Town of Parker Community Development Department
Development Review Division
Attention: **BrieAnna Simon**

Application Type: **Site Plan**
Status: **First Referral**
Application Name: **Douglas 234 F6 AMD 1 L3 – McDonalds**
Case/AP#: **SP21-067**
Referral Received: July 14, 2021
Comments Due: August 12, 2021

Review date: **August 2, 2021**
Plan reviewer: **Randall L. Capra, rcapra@parkeronline.org**
Phone: 303.805.3169

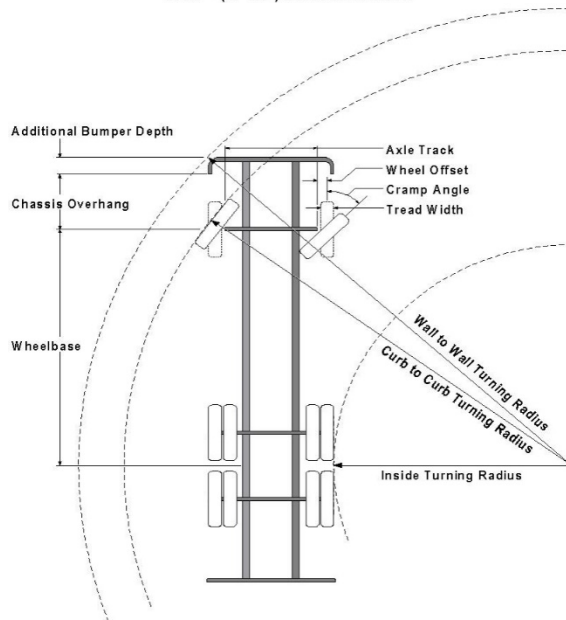
2. The applicant shall be aware that the access road hydrant distribution was not planned to address the suppression needs for all commercial properties within this subdivision; this site requires the addition of one hydrant (to be located at the s/w corner island of the building... as required per NFPA 24 Section 7.2.3... see the snap shot of the red-lined fire hydrant location shown under item 4 below:

4. As discussed in the pre-application meeting, the applicant will need to provide a fire hydrant interior to this site (once was not provided as directed); the applicant shall provide a fire hydrant in the area just southeast of the building... as required per NFPA 24, Section 7.2.3 (this section states that a fire hydrant shall be located not less than 40' from the building to be protected. See below for two acceptable locations and address this issue as required:
